Preliminary Change Request for the Chromatic Sextupoles and Trim Quadrupole Elements of the SNS Accumulator Ring

BNL/SNS TECHNICAL NOTE

NO. 075

May 30, 2000

Figure 1: Schematic layout showing dipole, quadrupole, sextupole, and corrector magnets of one lattice super-period. The chromatic sextupoles are shown in green.

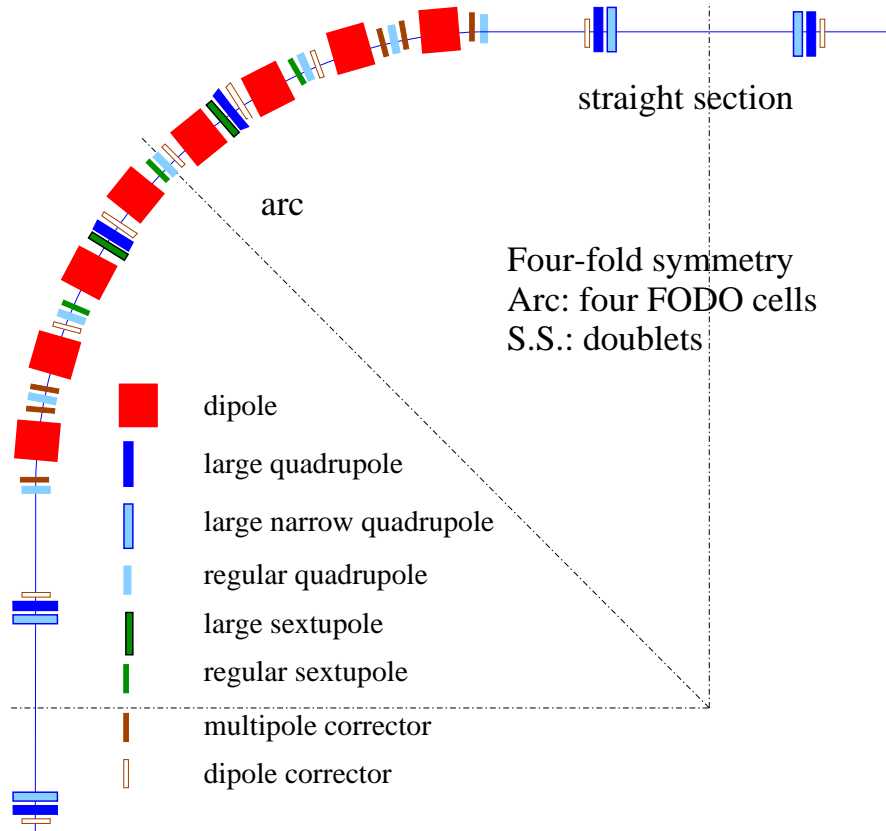
In the proposed lattice design, five chromatic sextupoles are placed downstream to the arc quadrupoles, at areas of large dispersion (Figs. 1 and 2). These “strong” sextupoles have been foreseen for adjusting the chromaticities to desired values, minimizing off-momentum optical mismatch and control resonance effects and instabilities [2].

Figure 3: Lattice functions of the SNS accumulator ring for the nominal tunes (6.3,5.8) using two families of sextupoles. The beta and dispersion functions are strongly perturbed for off-momentum cases.

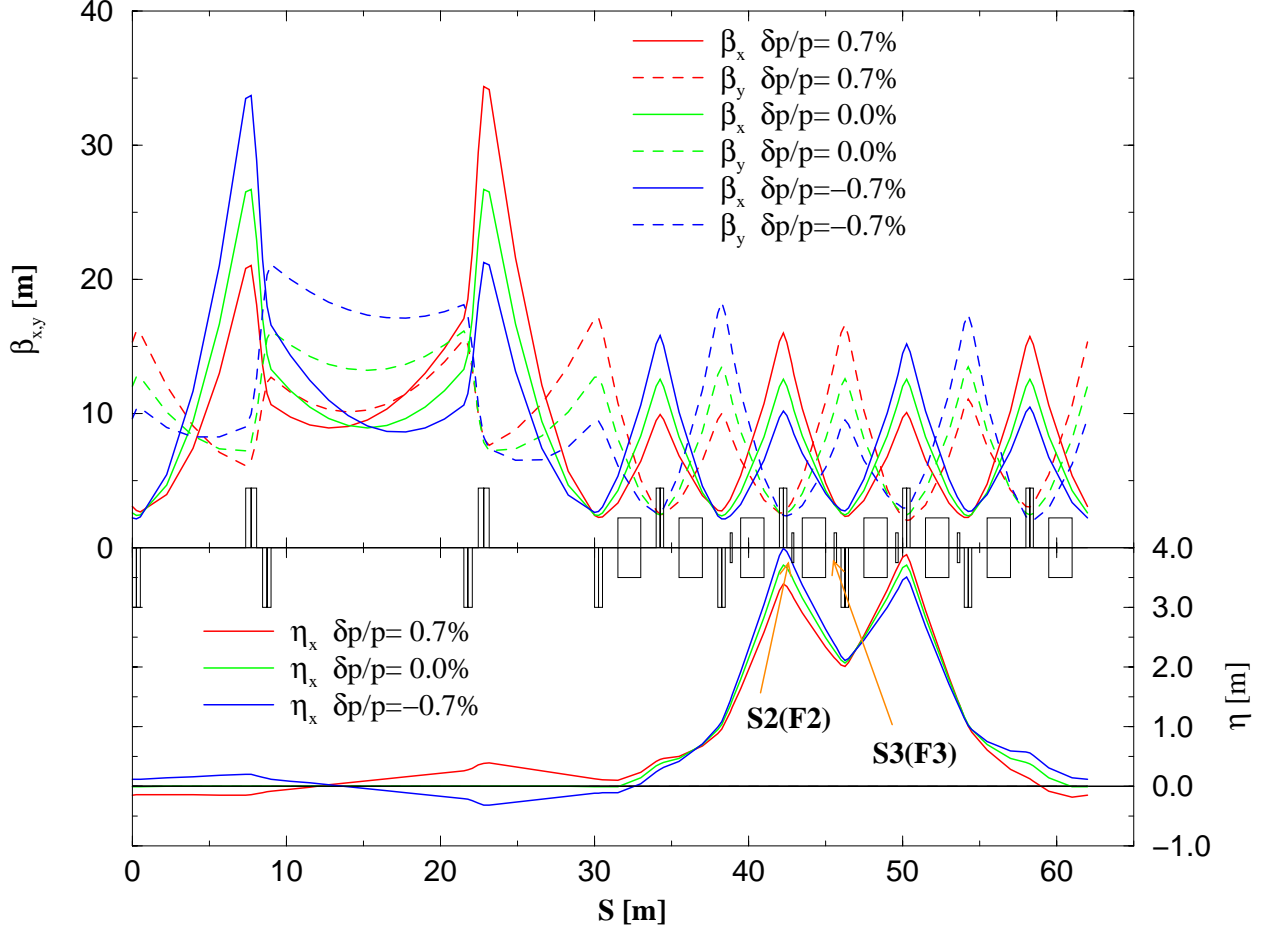
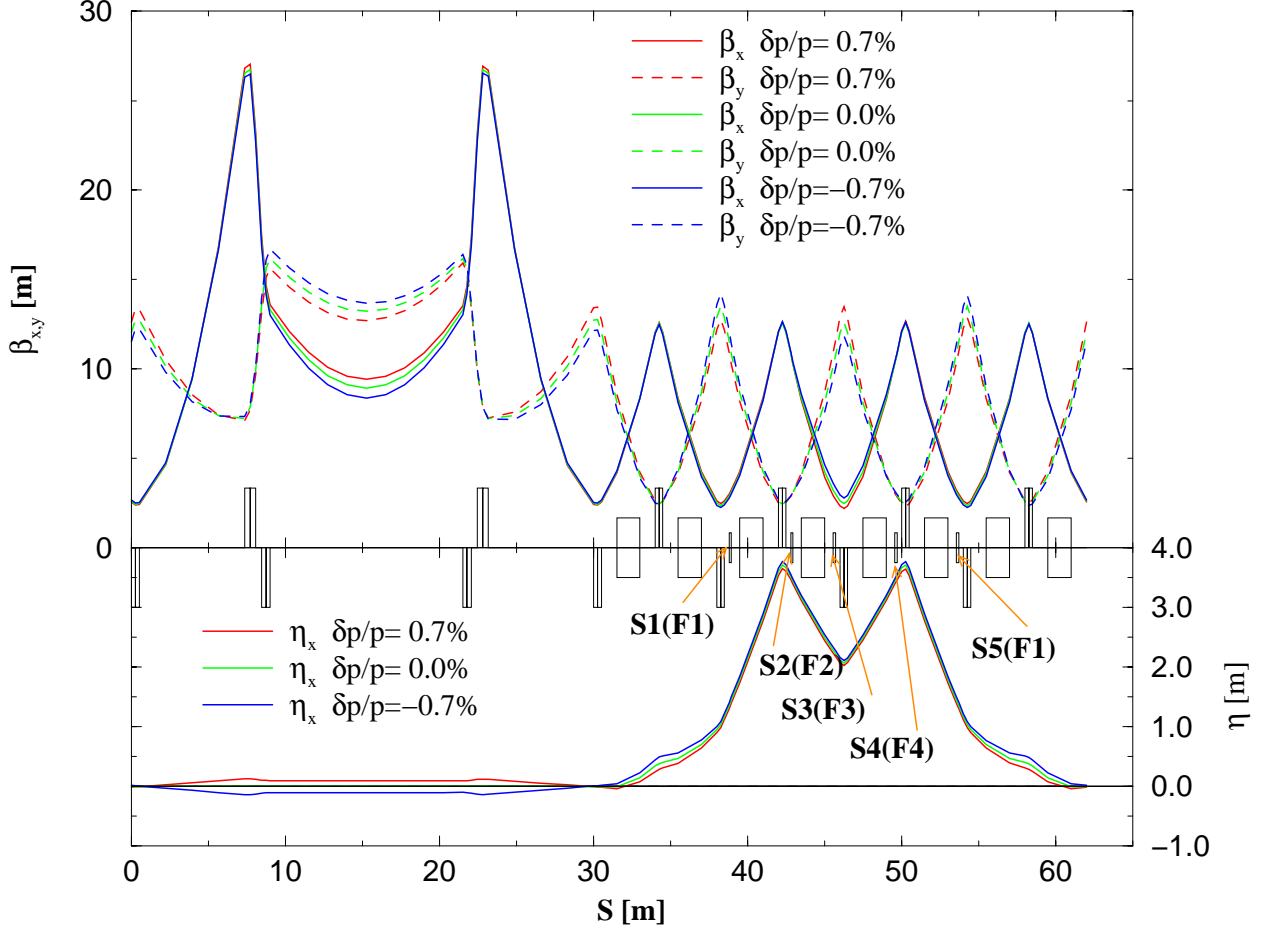
Two families of sextupoles, placed at high-beta and high-dispersion regions, can control the linear chromaticity of the ring. The sextupoles however may strongly affect the first and second order of the beta and dispersion functions dependence on the momentum spread, introducing strong “beta/dispersion waves” and, thereby, reducing the dynamic aperture. In addition, this beta/dispersion variation will increase the first and higher order terms of the chromaticity. This is clearly shown in figure 3: with a two-family scheme, the optical distortion in β -function is as large as 30% for off-momentum orbits.

In order to minimize the dependence of the beta, the dispersion functions and the chromaticity on $\delta p/p$, additional families of sextupoles are required. In the proposed chromaticity correction scheme, three of the sextupoles are powered independently and two of them in

series, forming a total of four families. With a four-family scheme, the off-momentum optics is greatly improved, and the β -wave is minimal (Fig. 4).

Figure 5: Sextupole strengths for the four families of chromatic sextupoles versus the chromaticity. The maximum values are within the strength requirements (Table 2.1).

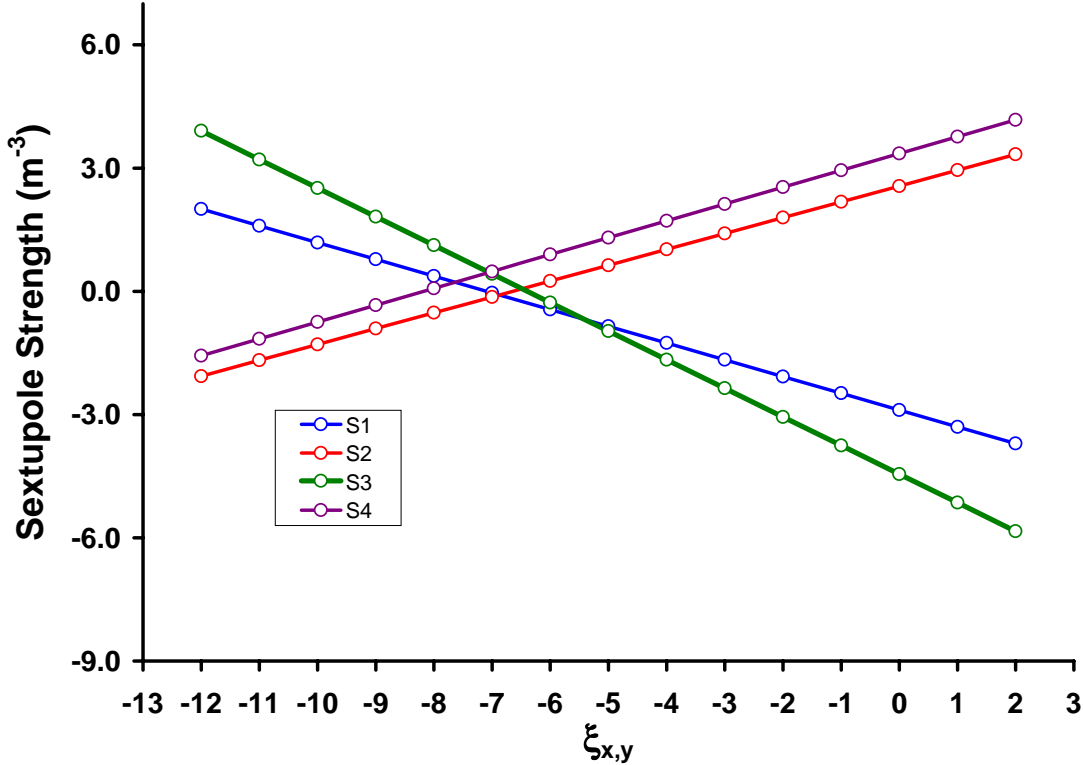
By using the HARMON module of the MAD program [4], we have computed the required strength of the four families of sextupoles in order to adjust the horizontal and vertical chromaticity $\xi_{x,y}$ to a wide value range and at the same time to minimize the optics functions' perturbation (Fig. 5). We observe that the sextupole strengths for the most extreme cases are less than 6m^{-3} . Thus, the strength requirements of 8.3m^{-3} , given in Table 2.1, are sufficient to handle the chromaticity/optics control, leaving a comfortable 20% margin.

Figure 6: Anharmonicities versus the chromaticity. The maximum values are within 5% of the ones produced by the quadrupole fringe-fields.

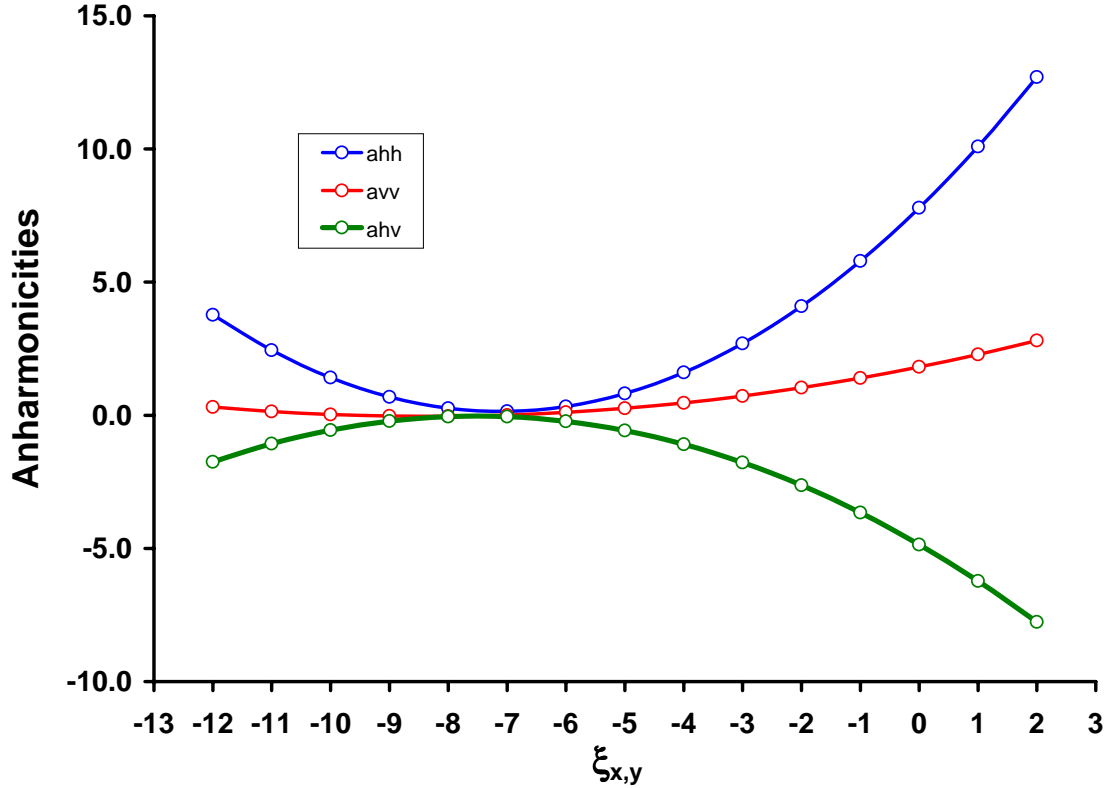
three quantities have been computed for all range of chromaticity values and plotted Fig. 6. The maximum anharmonicity values are found to be a factor of five smaller than the ones introduced by the quadrupole fringe-fields [5], indicating that the introduction of chromatic sextupoles will not have an important non-linear impact on the SNS ring. This residual octupole-like tune-shift can be corrected by dedicated octupole correctors [5]. Additional tracking studies are in progress in order to further justify the small impact of the chromatic sextupoles in the non-linear dynamics of the SNS ring.
